Access Compliance Report Public Rights-of-Way (Curb Ramps)

Intersection ID: 14714 Main Street: E MOREHEAD ST Cross Street: HARDING PL Location:

ADA ID: 7A79145DF77E Ramp Type: PerpDiag Initial Pass/Fail: Fail **Overall Compliance: No Severity Score:** 12.5

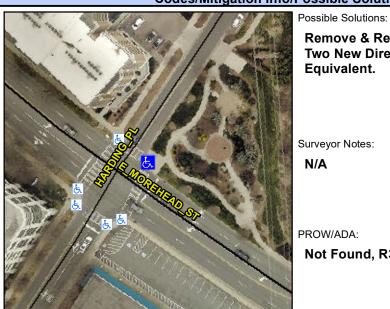
Not Found, R304.2.2

Field Measurements/Component Compilance					
Compliance Description		Data	Compliance Description		Data
N/A	Ramp Length (in)	59.0	No	Ramp Slope (%)	8.5
Yes	Ramp Width (in)	48.0	Yes	Ramp XSlope (%)	1.5
N/A	Flare Type LT	N/A	N/A	Flare Type RT	N/A
N/A	Flare Slope LT (%)	N/A	N/A	Flare Slope RT (%)	N/A
N/A	Flare Traversable LT?	N/A	N/A	Flare Traversable RT?	N/A
N/A	Landing Length (in)	N/A	N/A	DWS Provided?	N/A
N/A	Landing Width (in)	N/A	N/A	DWS Contrast?	N/A
N/A	Landing Slope (%)	N/A	N/A	DWS Length (in)	N/A
N/A	Landing X Slope (%)	N/A	N/A	DWS Full Width?	N/A
N/A	Landing Curb? (Y/N)	N/A	N/A	DWS Offset (in)	N/A
N/A	Shared Landing?	N/A			
N/A	Gutter Ponding?	N/A	N/A	Gutter Slope (%)	N/A
N/A	Gutter Lip Ht (in)	N/A	N/A	Gutter X Slope (%)	N/A
N/A	Painted X Walk1?	Yes	N/A	Painted X Walk2?	Yes
	X Walk 1 Direction	To NW		X Walk 2 Direction	To SW
N/A	X Walk 1 Width (in)	112.0	N/A	X Walk 2 Width (in)	105.0
	X Walk 1 Slope (%)	3.7		X Walk 2 Slope (%)	3.5

Remove & Replace Curb Ramp With Two New Directional Ramps or Equivalent.
